KWM-380

Service Bulletins

AC-3803 CONTROL INTERFACE KIT (641-7150-001)
CONTROL INTERFACE CIRCUIT CARD (638-6910-001)

SERVICE BULLETIN NO 1

P/O Receiver/Exciter A3, Component
Installation Diagram
Figure 1 (Sheet 1 of 2)

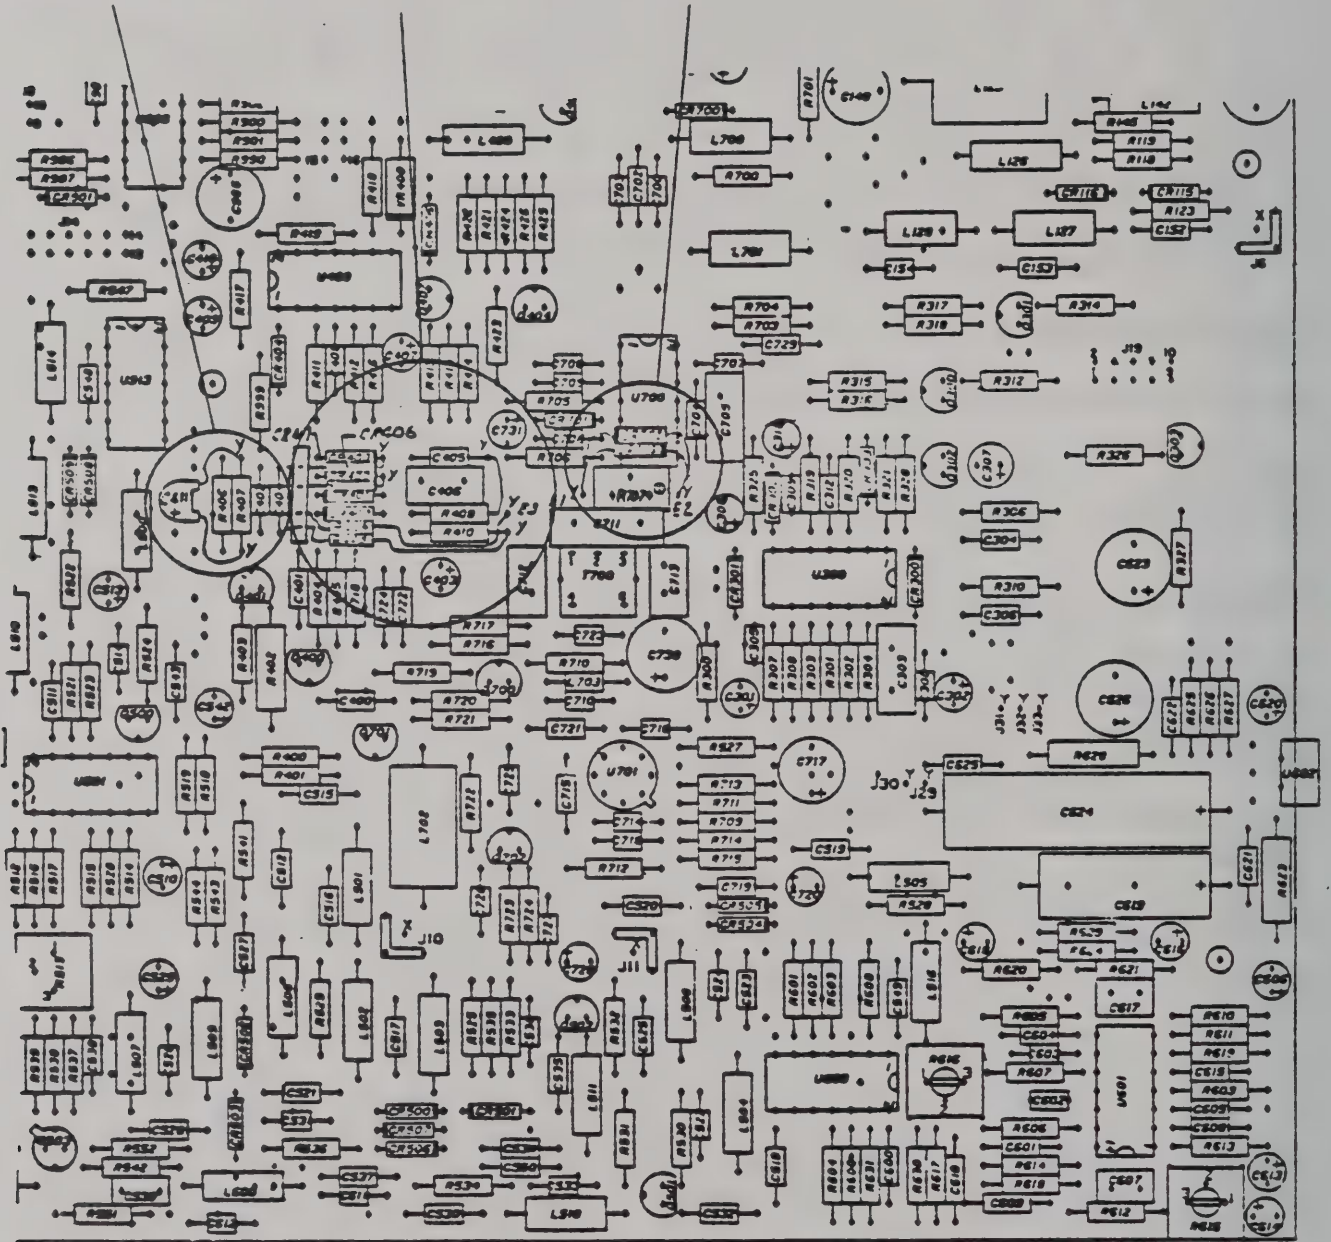
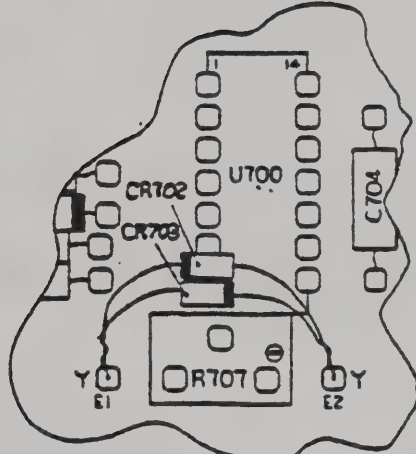
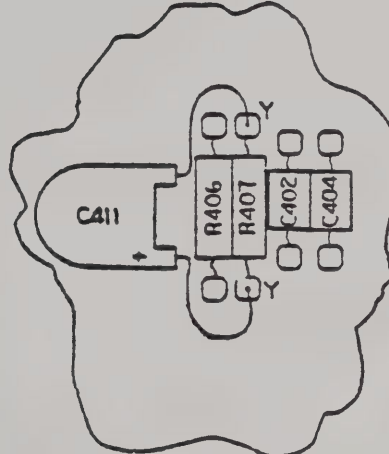
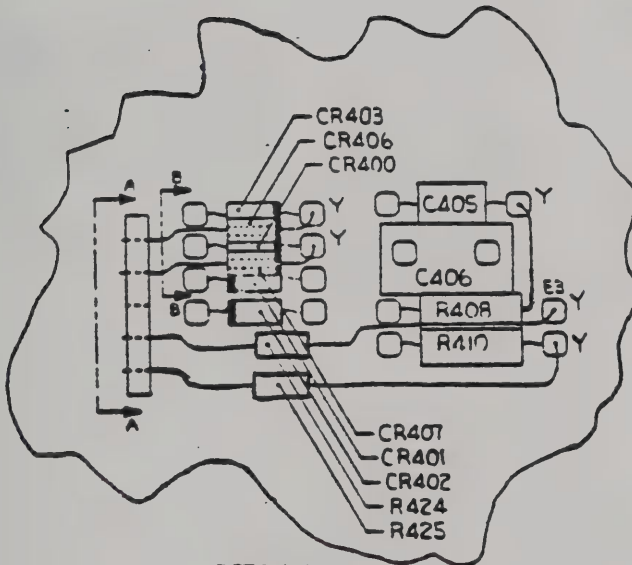
- C. Install contacts, 372-2656-130 (square pins) at E1 and E2 (holes in board) and solder. Refer to figure 1, detail A.
- D. Install 1N4454 diode CR702 (353-3644-010) with cathode to E1 as shown in figure 1, detail A.

- E. Install 1N4454 diode CR703 (353-3644-010) with cathode to E2 as shown in figure 1, detail A.
- F. Remove both leads of resistor R407 and install a contact (372-2656-130) in each hole.

- G. Connect the R407 leads to the new contacts.
- H. Install 100 μ F capacitor C411 (184-9102-100) to the new contacts with the positive side to the bottom of R407 as shown in figure 1, detail C.

- K. Position 1N4454 diode CR406 (353-3644-010) as shown in figure 1, detail B, section BB. Connect the cathode end to the contact installed in step I.

- L. Position 1N4454 diode CR407 (353-3644-010) as shown in figure 1, detail B, section BB. Connect the cathode end to the contact installed in step J.

- R. Connect the right hand lead of 7.50 k Ω resistor R425 (705-1038-000) to the contact installed in step O.
- S. Cut a terminal strip (797-3615-001) into one block of five holes.
- T. Position the terminal block as shown in figure 1, detail B, and secure it to the circuit card using commercially available epoxy or bonding adhesive.
- U. Connect the left hand leads of CR406, CR407, R424, and R425 into the terminal block as shown.
- V. Stamp RWK REV J on receiver/exciter card A3 near the latest REV letter.
- W. Reinstall the transceiver dust cover.
- X. Mark SB 8 on the service bulletin information chart. If the transceiver does not have an information chart, install a chart (280-3778-010) near the nameplate.

P/O Receiver/Exciter A3, Component Installation Diagram
Figure 1 (Sheet 1 of 2)

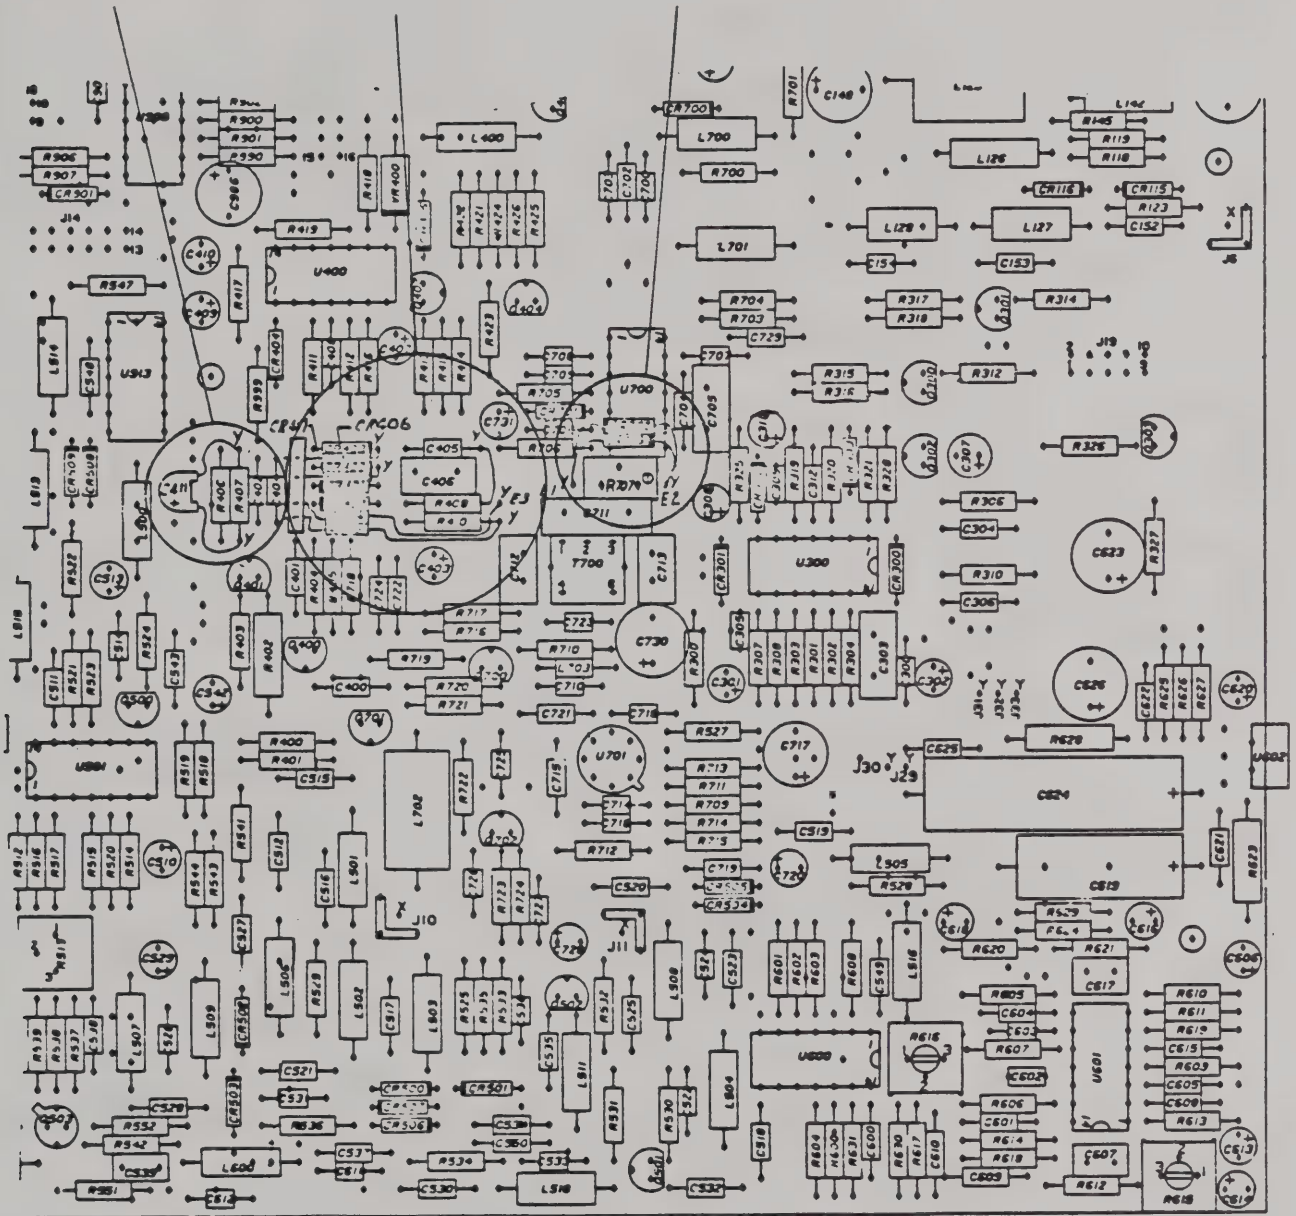
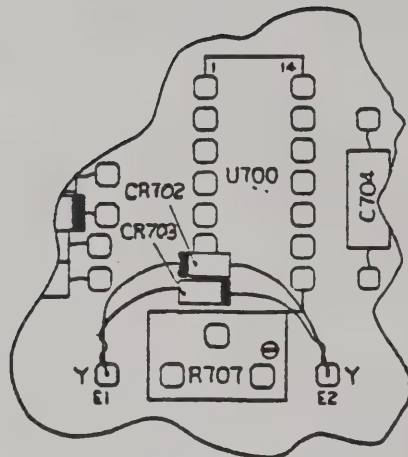
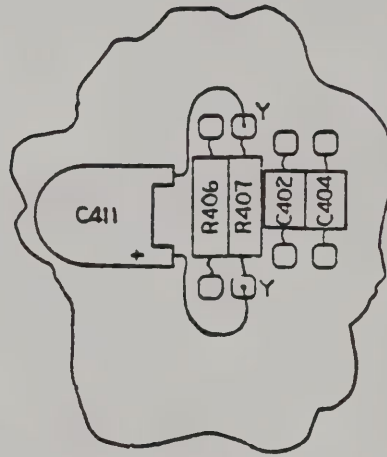
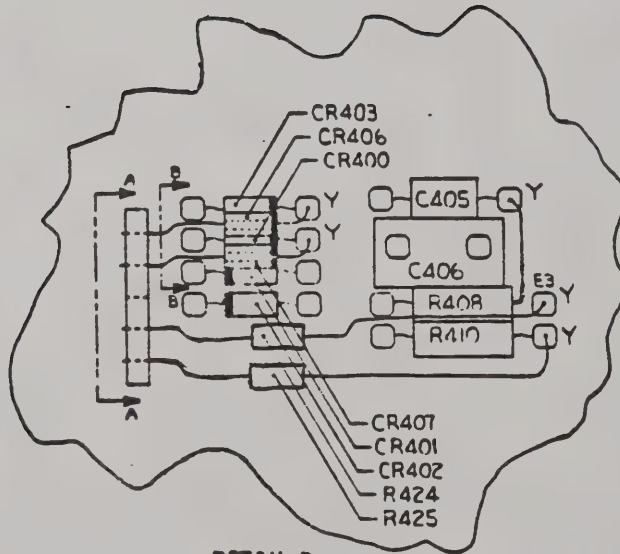
- C. Install contacts, 372-2656-130 (square pins) at E1 and E2 (holes in board) and solder. Refer to figure 1, detail A.
- D. Install 1N4454 diode CR702 (353-3644-010) with cathode to E1 as shown in figure 1, detail A.
- E. Install 1N4454 diode CR703 (353-3644-010) with cathode to E2 as shown in figure 1, detail A.

- F. Remove both leads of resistor R407 and install a contact (372-2656-130) in each hole.
- G. Connect the R407 leads to the new contacts.
- H. Install 100- μ F capacitor C411 (184-9102-100) to the new contacts with the positive side to the bottom of R407 as shown in figure 1, detail C.

- K. Position 1N4454 diode CR406 (353-3644-010) as shown in figure 1, detail B, section BB. Connect the cathode end to the contact installed in step I.

- L. Position 1N4454 diode CR407 (353-3644-010) as shown in figure 1, detail B, section BB. Connect the cathode end to the contact installed in step J.

- S. Cut a terminal strip (797-3615-001) into one block of five holes.
- T. Position the terminal block as shown in figure 1, detail B, and secure it to the circuit card using commercially available epoxy or bonding adhesive.

Power Amplifier A1A1,
 After Modification
 Figure 1 (Sheet 2)

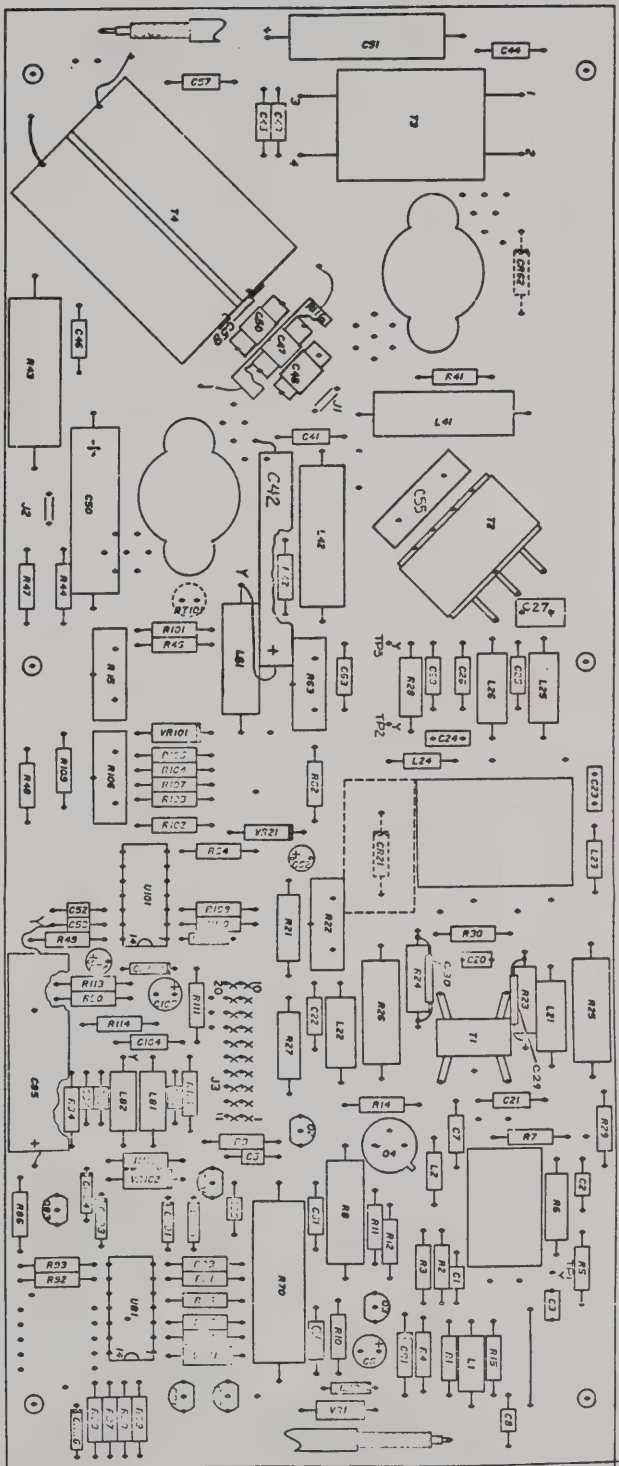
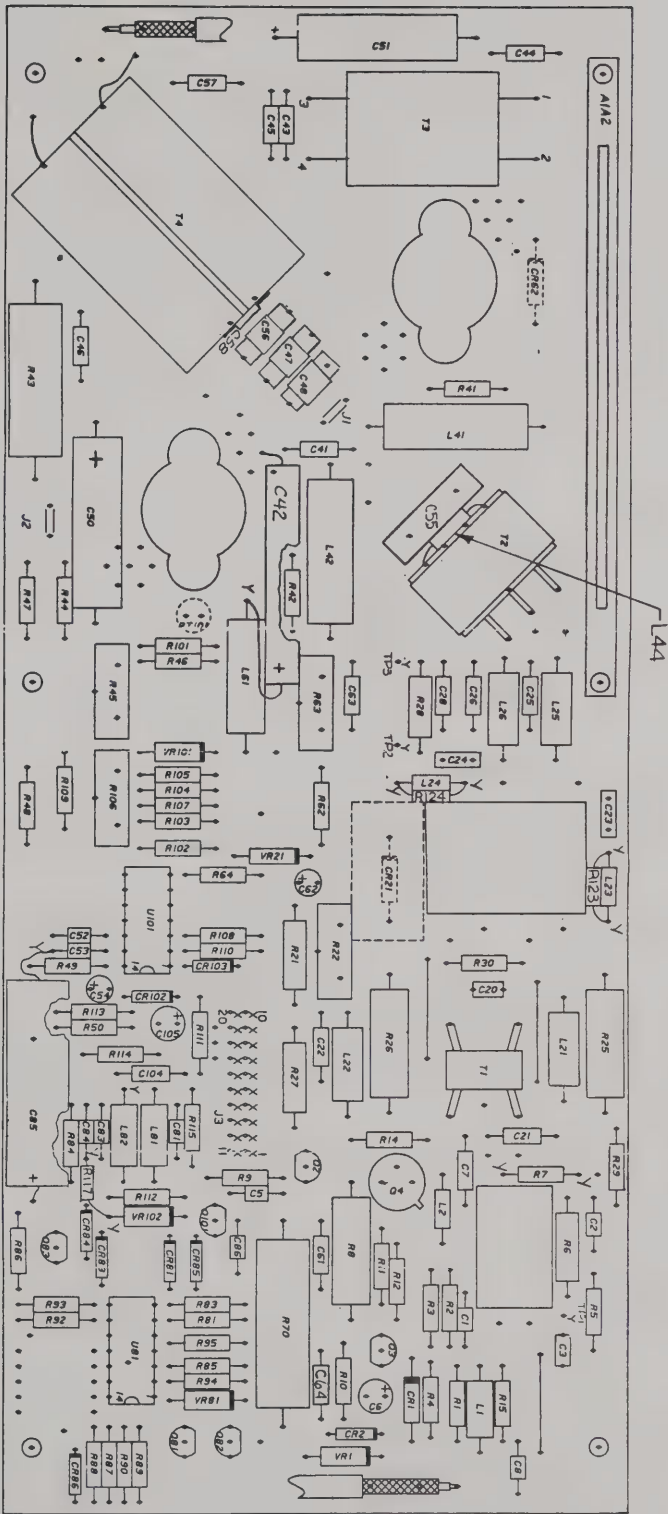
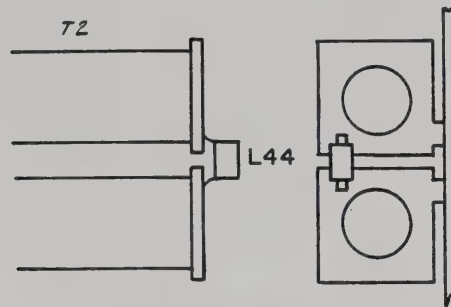
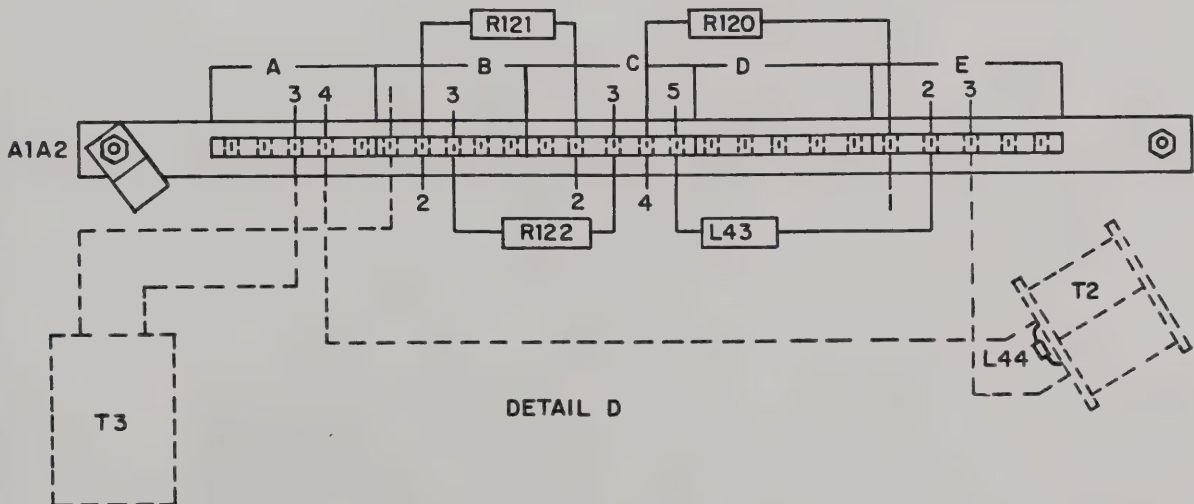
- E. Remove 1500-pF capacitor C55 by cutting the leads close to the body of the component. Leave the capacitor leads soldered into the circuit card.
- F. Install a 1000-pF capacitor (912-3315-000), connecting the leads to the leads of the capacitor removed in step E.
- G. Install a 2.7- μ H coil L44 (240-2715-180) as shown in figure 1, detail A.
- H. Remove 0.27- μ H inductors L23 and L24 by cutting the leads close to the component body. Leave the inductor leads soldered into the circuit card.
- I. Install two 3.3- μ H inductors (240-2029-000), connecting the leads to the leads of the inductors removed in step H.
- J. Install 100- Ω resistor R123 (745-1310-000) in parallel with L23. Wrap the resistor leads around the coil leads and solder.

- S. Wind two turns of brown wire (422-0795-000) in transformer T3 as shown in figure 1, detail B. Connect to A1A2 assembly as shown in figure 1, detail D. If the transformer core has potting in the holes, carefully clear a way for the brown wire, using a stiff wire such as a straightened paper clip.
- T. Wind two turns of red wire (442-0796-000) in transformer T2 as shown in figure 1, detail D. If necessary, clear the core of potting as in step S.

NOTE: The added wires in steps S and T must be oriented as shown in figure 1, details B and C, to prevent oscillation.

- Q. Remove and discard 68- Ω resistor R116.
- R. Install electronic components assembly A1A2 (647-2781-001) onto the circuit card as shown in figure 1 using the existing hardware.

- S. Wind two turns of brown wire (422-0795-000) in transformer T3 as shown in figure 1, detail B. Connect to A1A2 assembly as shown in figure 1, detail D. If the transformer core has potting in the holes, carefully clear a way for the brown wire, using a stiff wire such as a straightened paper clip.

- T. Wind two turns of red wire (442-0796-000) in transformer T2 as shown in figure 1, detail D. If necessary, clear the core of potting as in step S.
- NOTE: The added wires in steps S and T must be oriented as shown in figure 1, details B and C, to prevent oscillation.

Power Amplifier A1A1,
 Schematic Diagram
 Figure 2

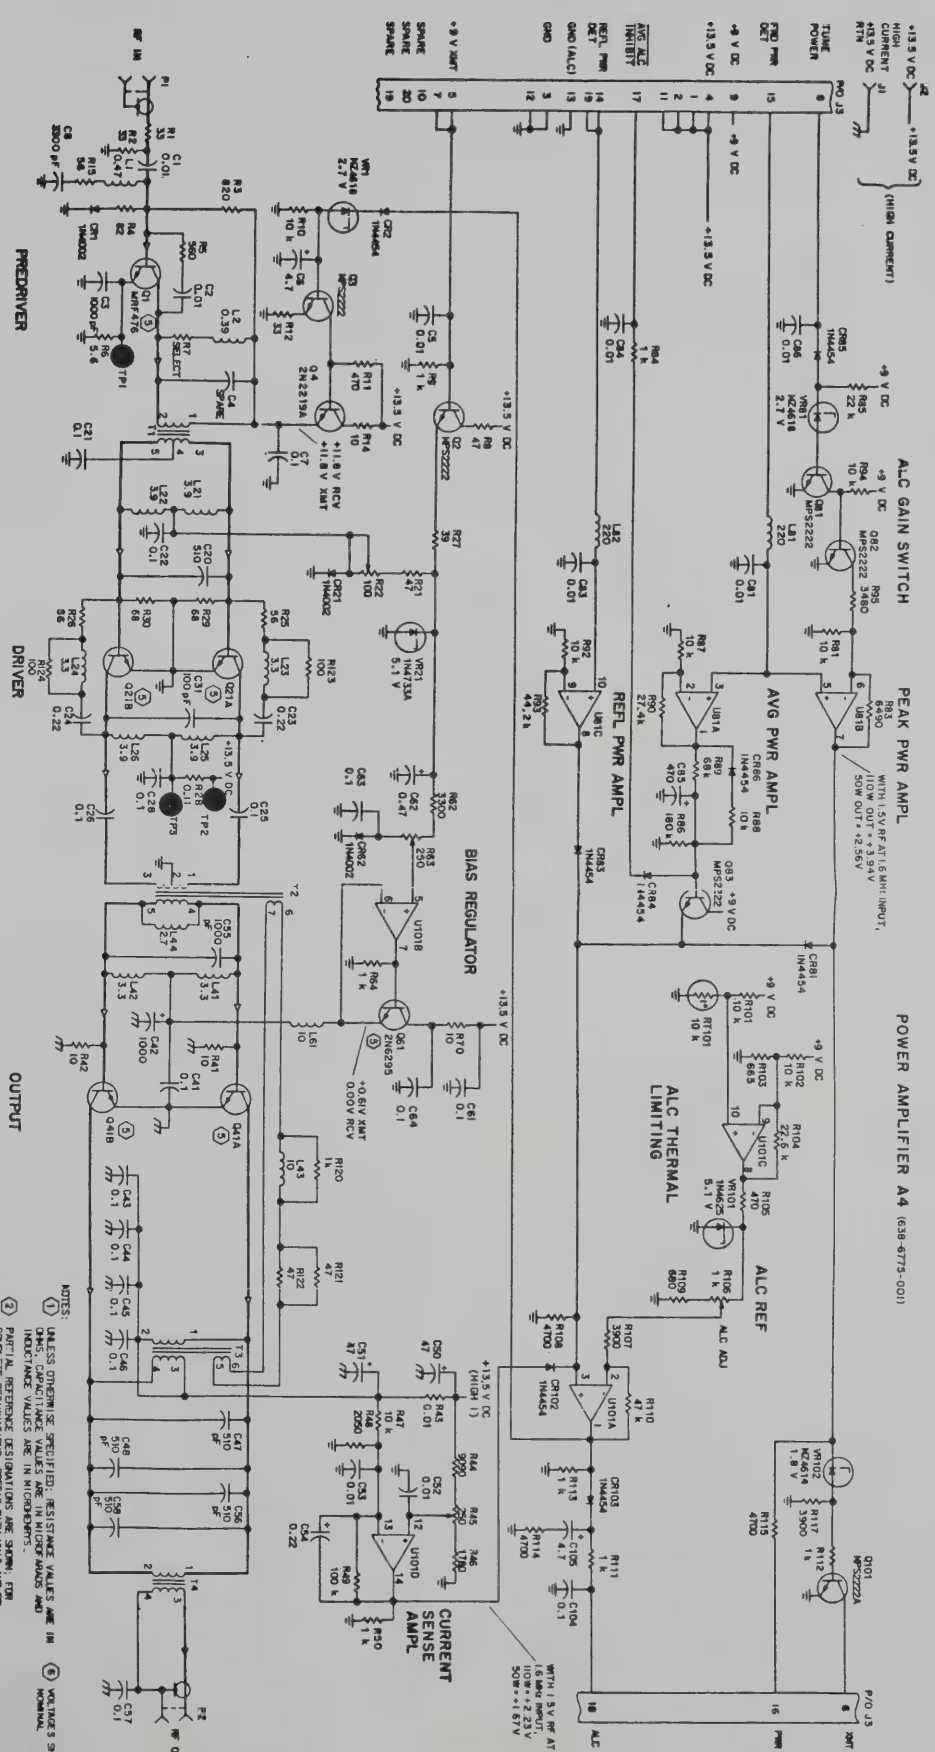
NOTE: Do not remove circuit card A1A1 from power amplifier/heat sink assembly A1. Refer to figure 1 while performing steps E through T. Refer to figure 2 for a schematic diagram of the latest configuration.

Transceiver, Bottom View
Figure 1

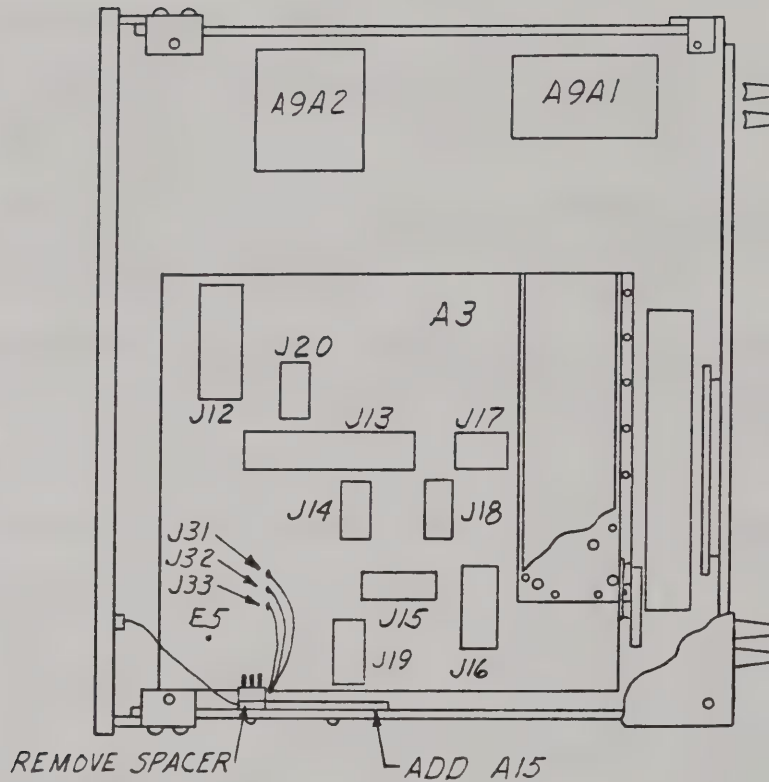
- E. Remove spacer as shown in figure 1.
- F. Install mounting bracket and circuit card A15 (step D) into transceiver using screw where spacer was removed and one additional screw (343-0167-000) in an existing hole in chassis.
- G. Inspect receiver-exciter card A3 to determine if W3 is connected from R713 to E5 as shown in figure 3. If this wire has been installed, proceed to step N. If W3 is not present, perform steps H through M.
- H. Lift the left-hand lead of 180- Ω resistor R713 and install a square pin (372-2601-045) from the top of the card into the hole vacated by the lead. Solder the square pin.
- I. Reconnect the R713 lead to the square pin.
